Planning and Zoning Board Agenda July 14, 2020

- A. Approval of the Minutes of the 6/9/20 PZB Meeting
- B. Site Plan – Progress Park Parcels G & H: A request by Sergio Reyes, P.E., of EDA Consultants,

Inc., applicant and agent for Ponce Inlet Investments, LLC, property owner, for consideration of a Site Plan to construct a ±12,568 square foot building with associated parking, stormwater, landscaping, and site improvements on a ±5.06 acre subject property. Tax Parcel Number 03956-010-028 (Quasi-Judicial Hearing).

\\server3\engprojects\Progress Center Parcels G & H (2019)\Plans\Current DWG\19054_LANDSCAPE.dwg-L300 LANDSCAPE PLAN Jun 22, 2020 MSwider

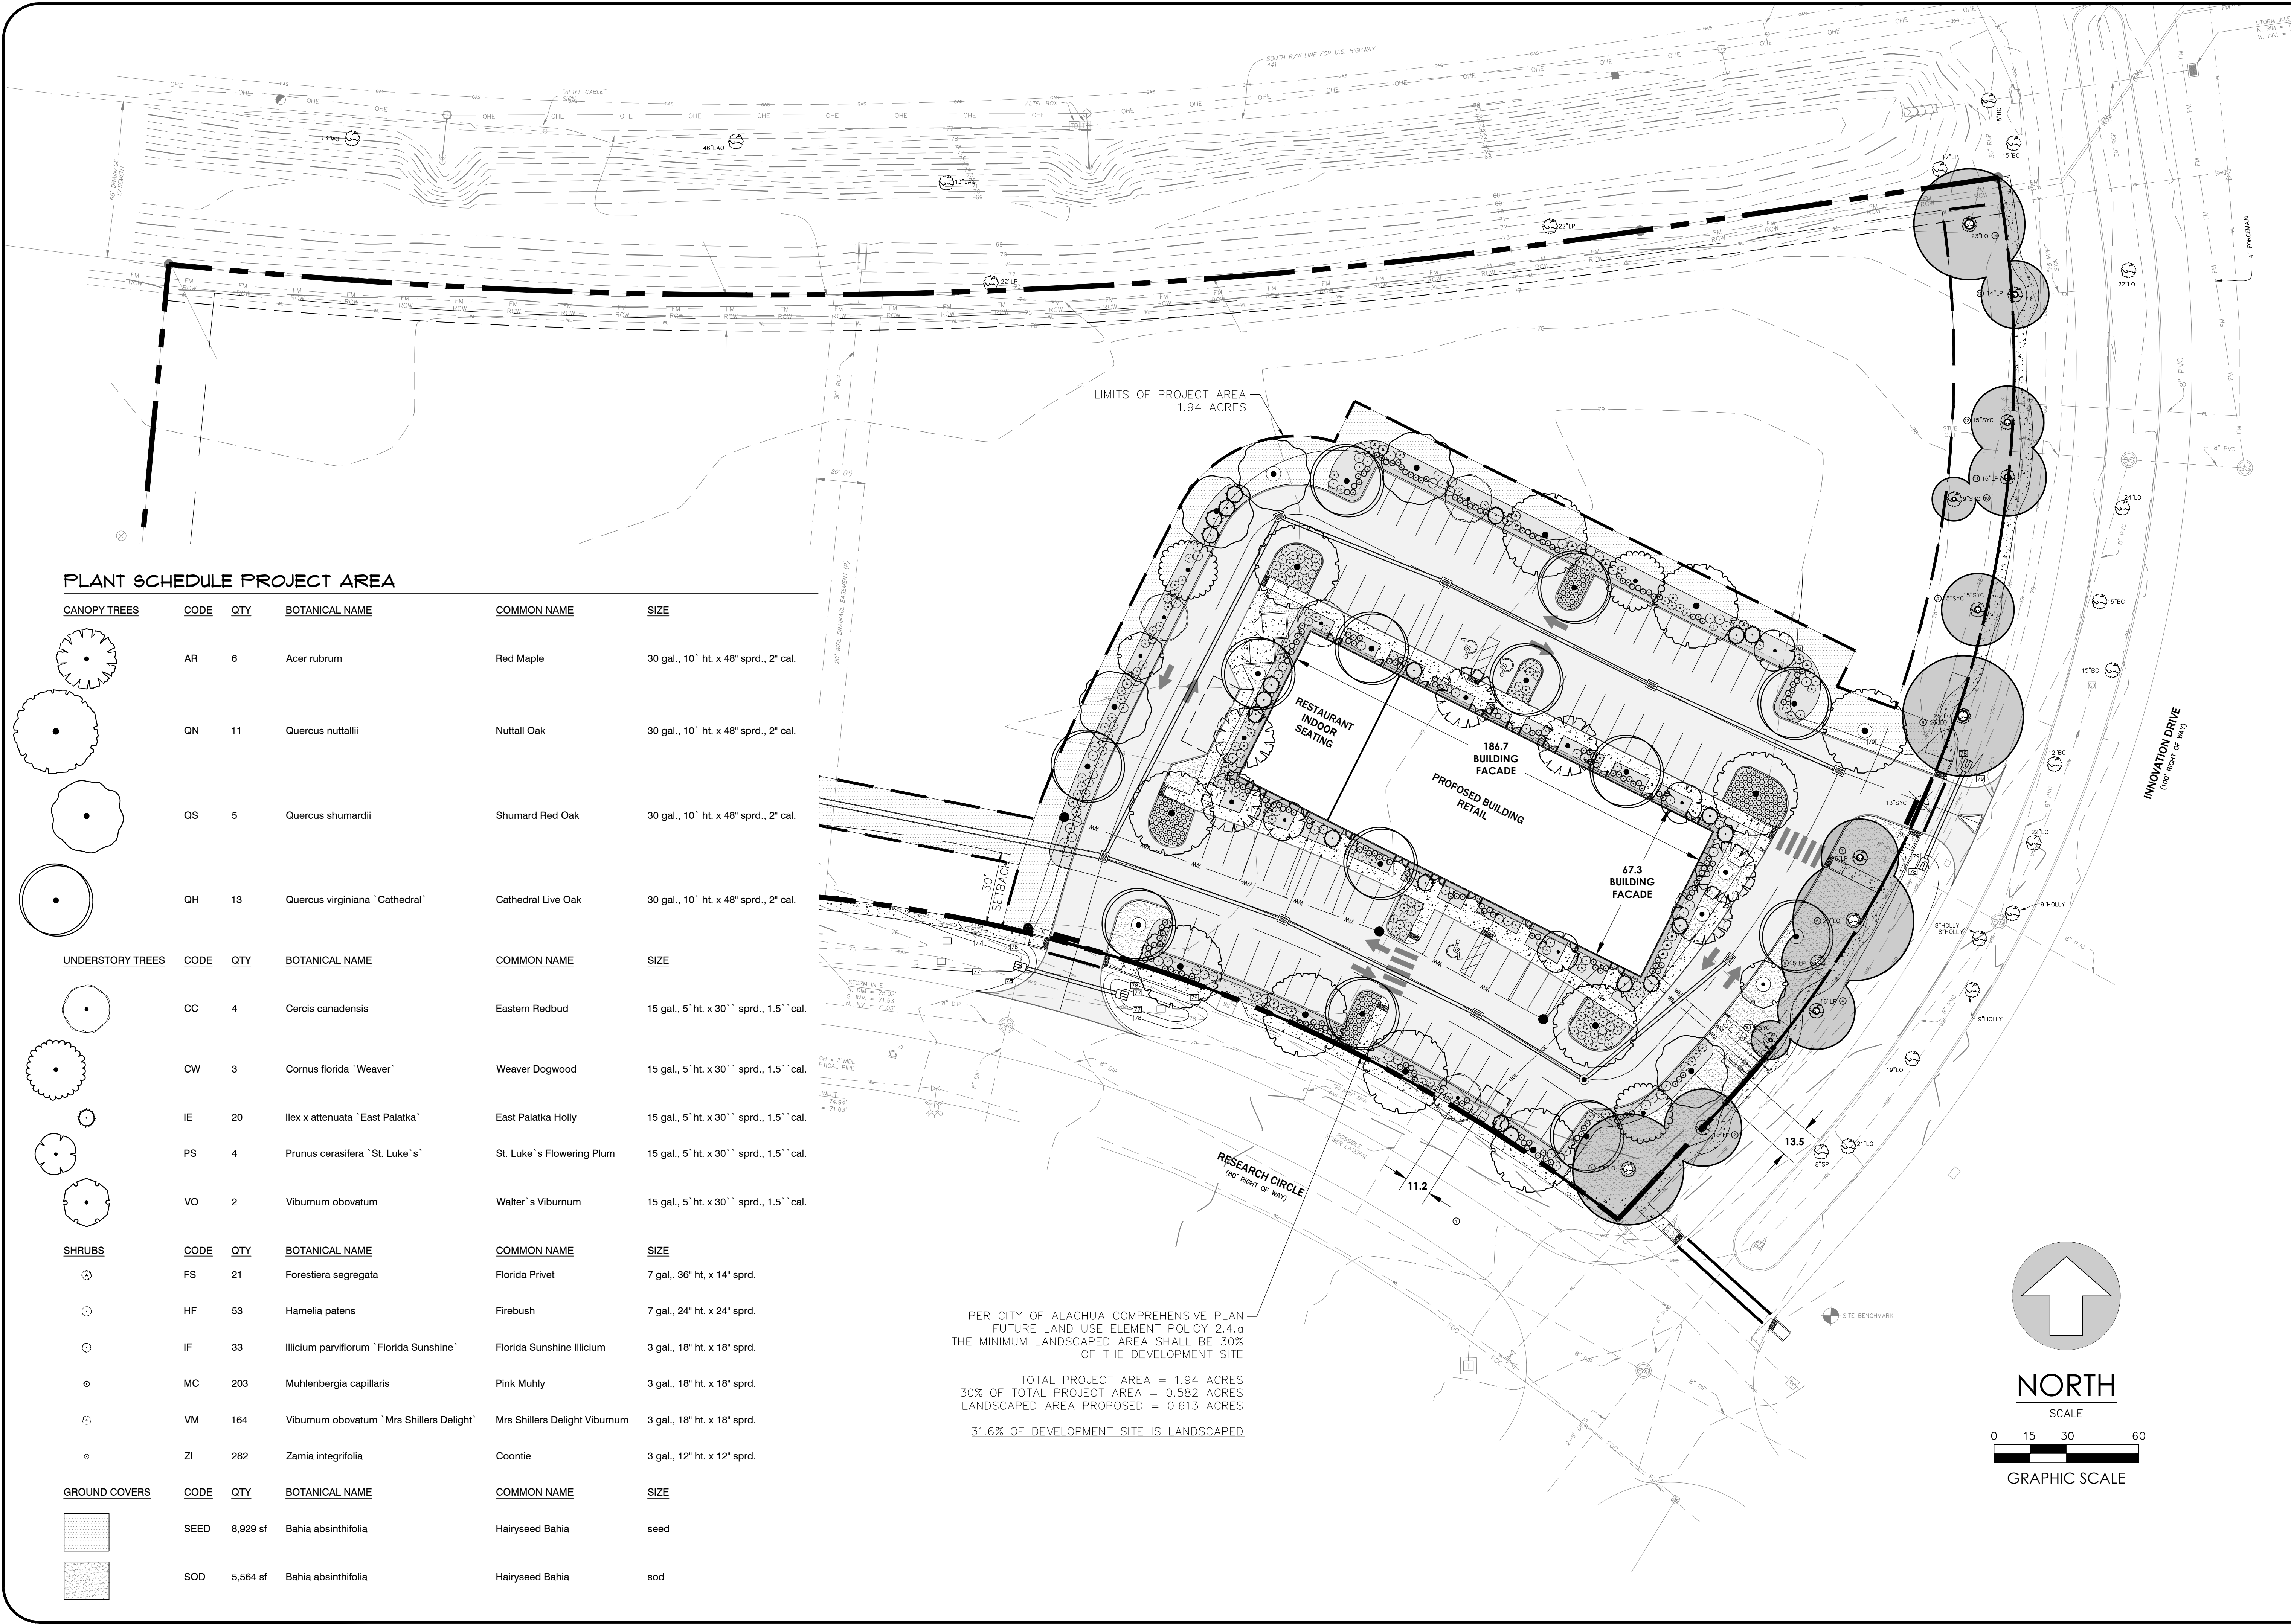
NO.	COMMENTS
	restraint and tracer wires. Comment on June 2nd Submittal Approved
8.	Comment on Apr 30th/May 13th Submittal Sheet L300 - Note 5 says no permanent structure within 10 feet of any water line or 15 feet from any sewer line. Suggest that a minimum distance from trees be added. As per CoA DCM, for both water and wastewater pipes, the minimum required distances from trees is 15 feet and from structures is 7.5 ft. - In particular, evaluate tree locations near the water supply meter and fire line backflow preventer (Sheet C400, Keyed Notes 3 & 4). - Because most water and wastewater piping is on private property, the CoA is willing relax some of its guidelines. - Also, trees appear very close to the transformer. (Sheet C400). This is likely a moot point, as the transformer will probably be relocated. - Once the transformer is relocated, note that its minimum distance from both trees and structures is 10 feet as per CoA DCM. Comment on June 2nd Submittal Sheet L300 - Near the proposed water main from the street to the building, there is an existing sycamore tree whose roots will interfere with the proposed water main. Please remove this tree. - This is now a moot point, but keep new trees far enough away from new transformers and underground utilities. As now shown, there are new red oak and eastern redbud trees very close to underground utility lines and the above-grade transformer. Location of the secondary transformer will likely change, but please keep trees far removed from the new locations of secondary transformers and electrical devices.

RESPONSE: *Minimum distance from water and wastewater pipes has been considered and the landscape plan has been revised accordingly to ensure no canopy trees are proposed within 10 feet from any structure as per CoA DCM. Refer to dimension offset callouts on the Landscape Plan on Sheet L300.*

RESPONSE: Required utility offsets have been taken into consideration with the proposed tree locations. Refer to Sheet L300 for updated Landscape Plan.

PROGRESS CENTER PARCELS
SITE LIGHTING PLAN
CITY OF ALACHUA, FLORIDA

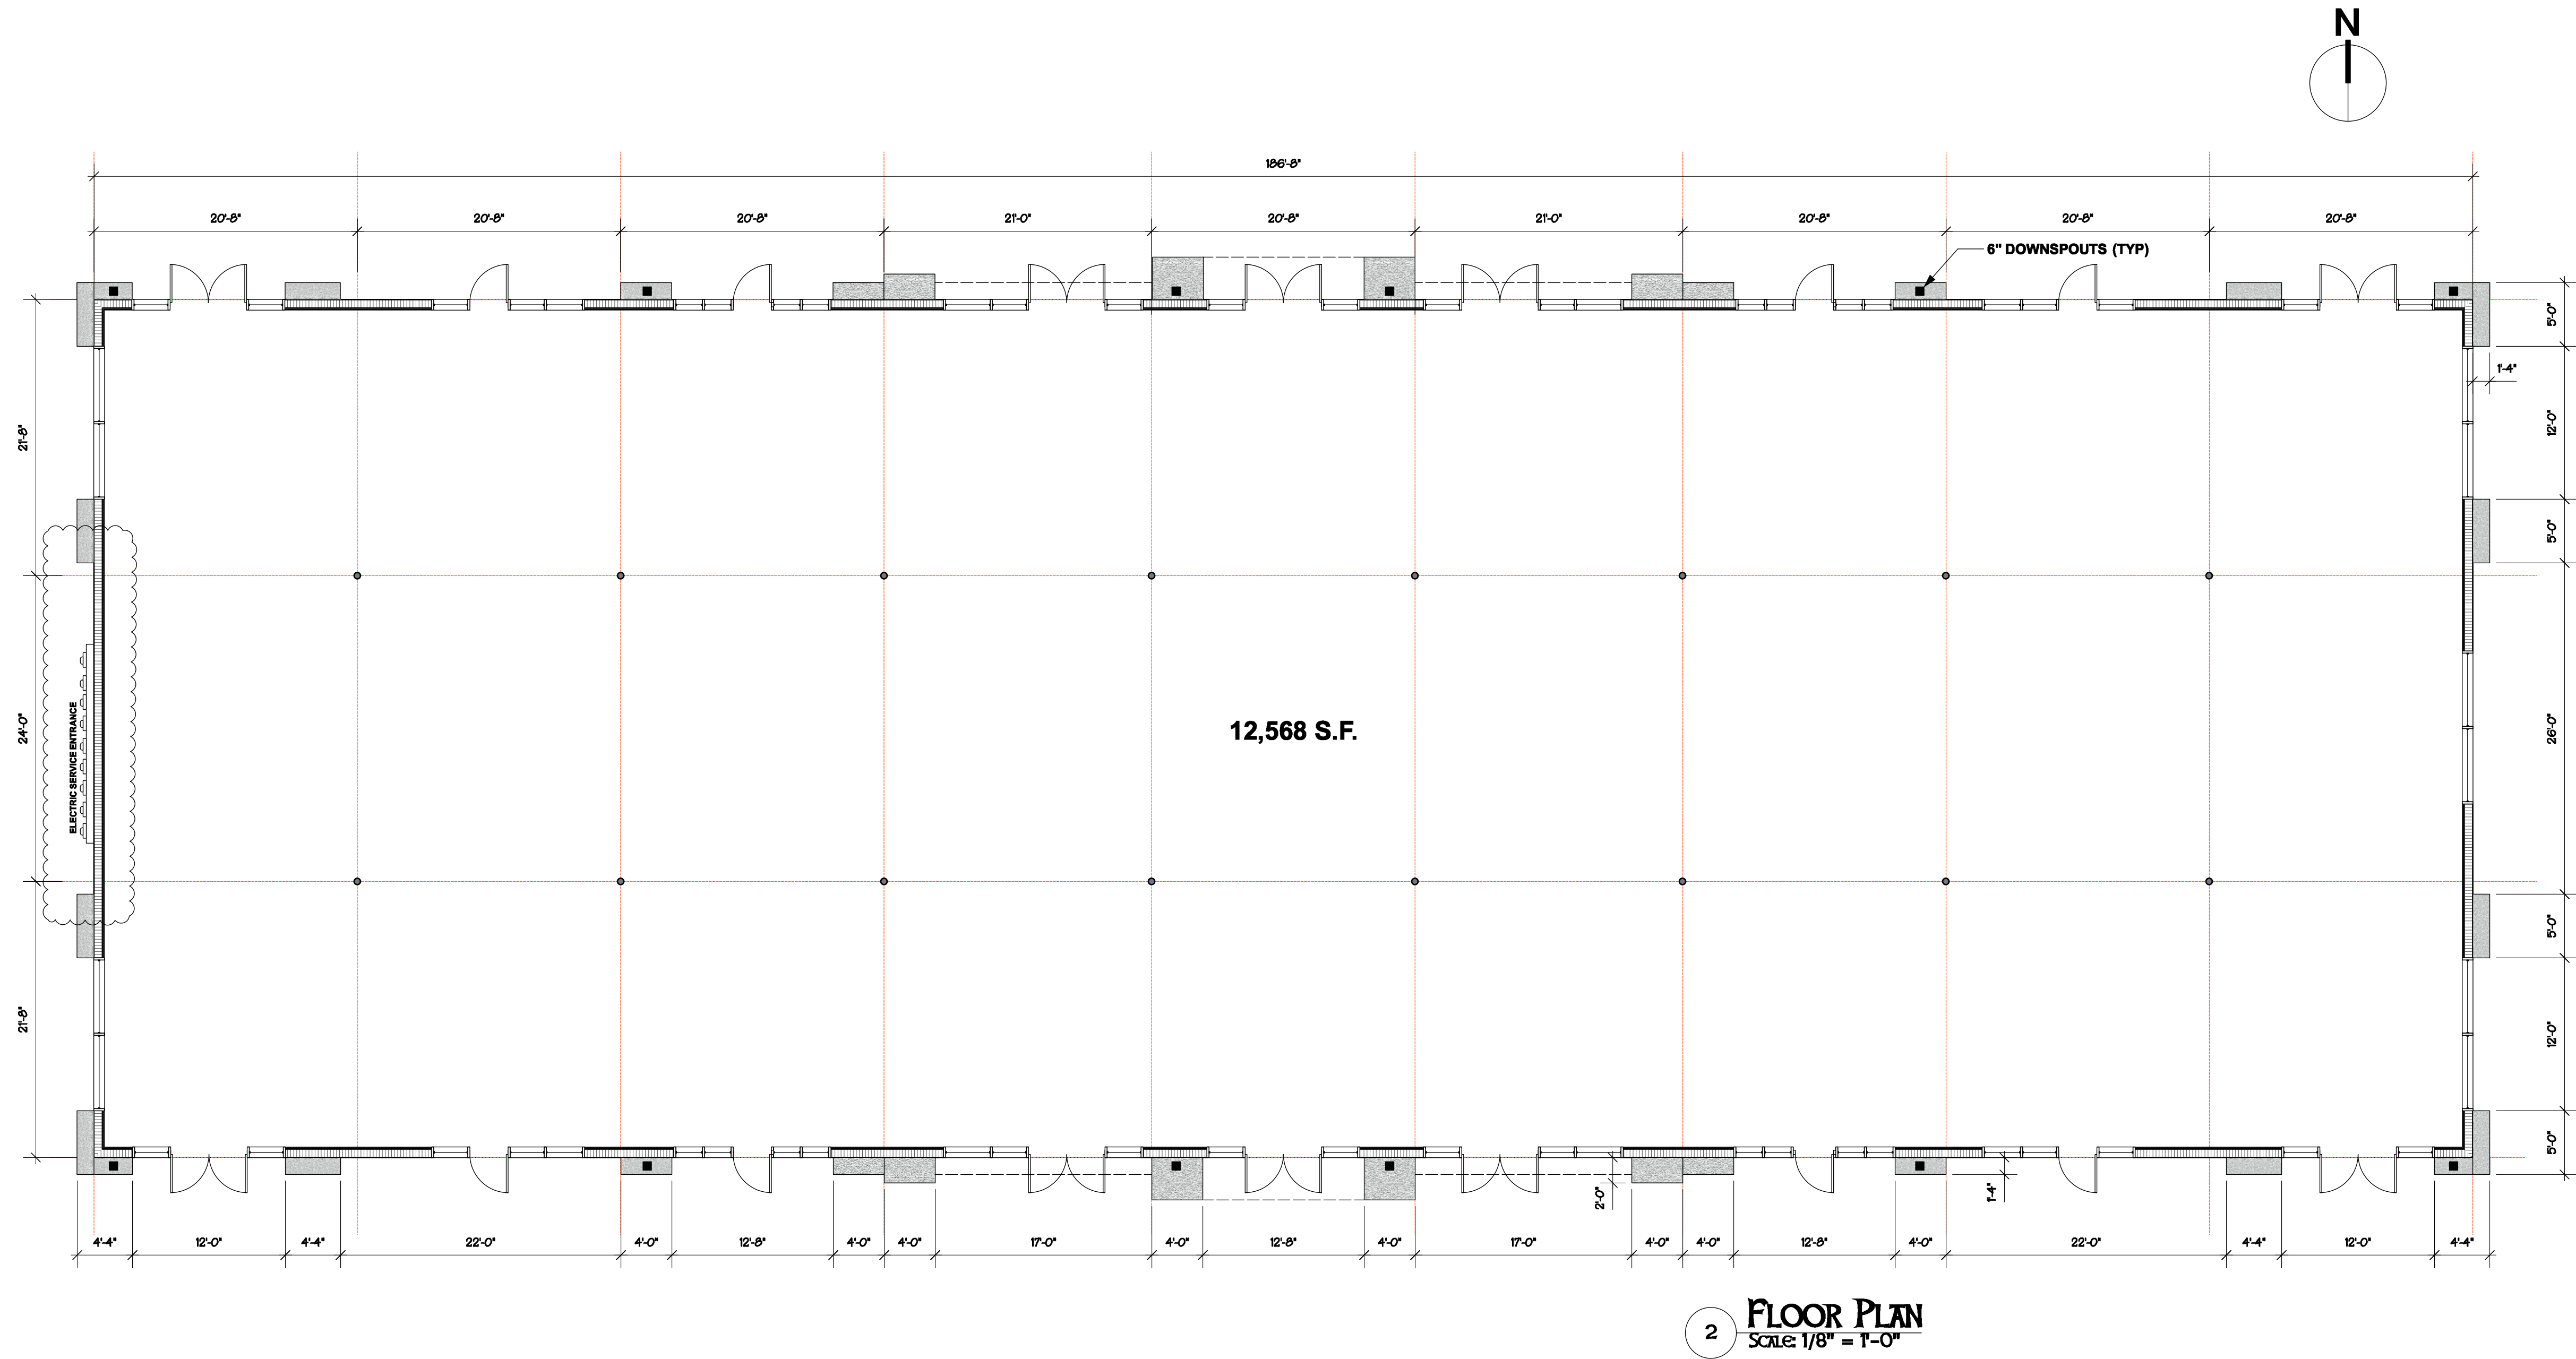
j. Sheet E-1: Correct the title of the column indicating the height of each light fixture in the luminaire schedule.

RESPONSE: A light loss factor has not been applied. Please see revised sheet E-1.

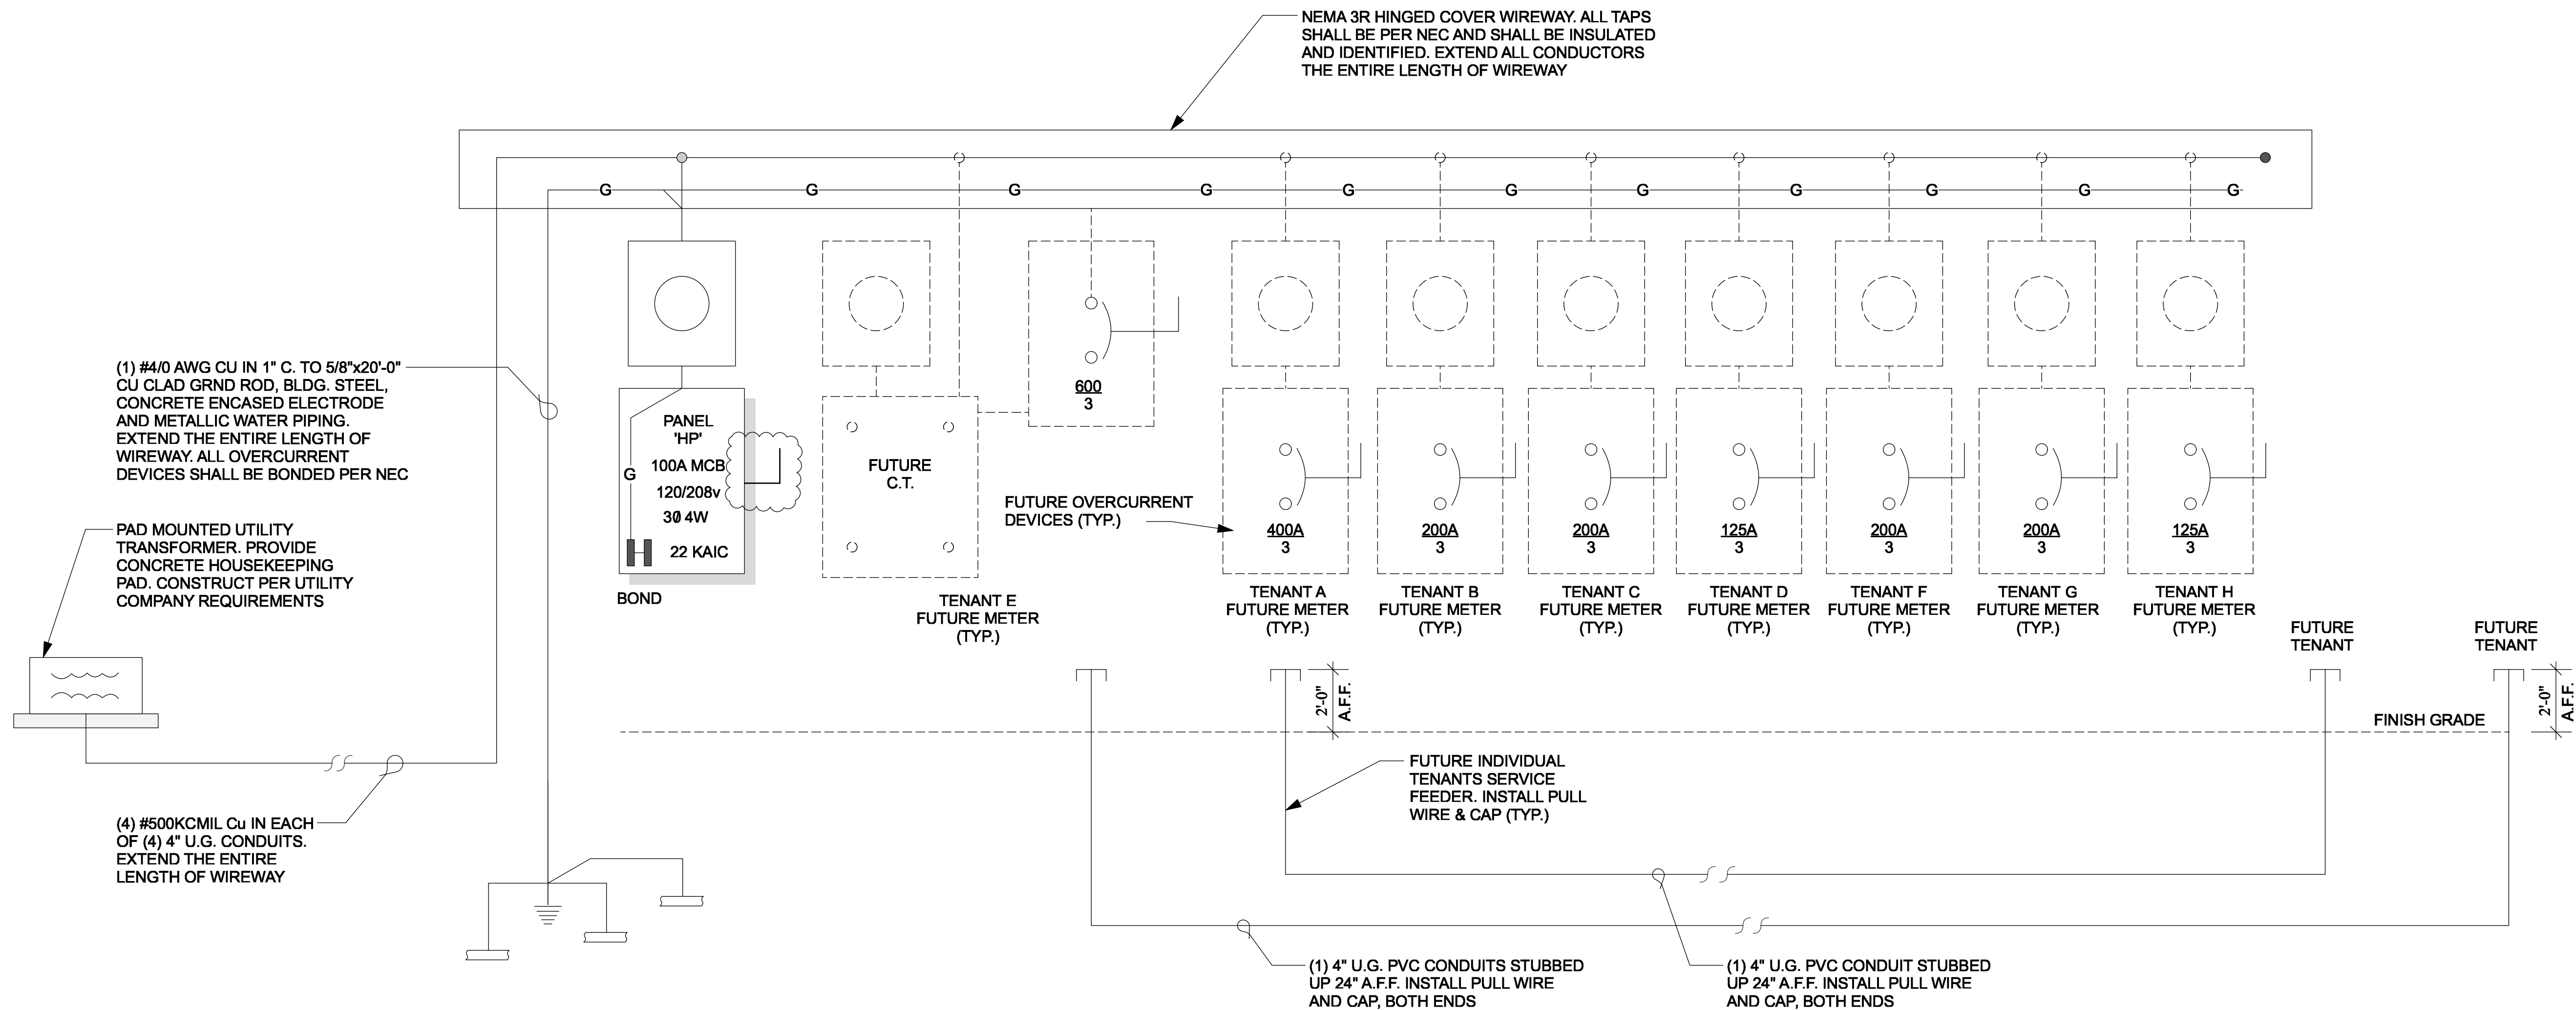
NO.	COMMENTS
	Sheet E100 The 1167 amp preliminary load is calculated by dividing 420, 090 va by 360. What does 360 represent and what are its units? Where is the disconnect switch located for the proposed load (not future). Is it located in Panel HP? If so, please show it.
END OF COMMENTS
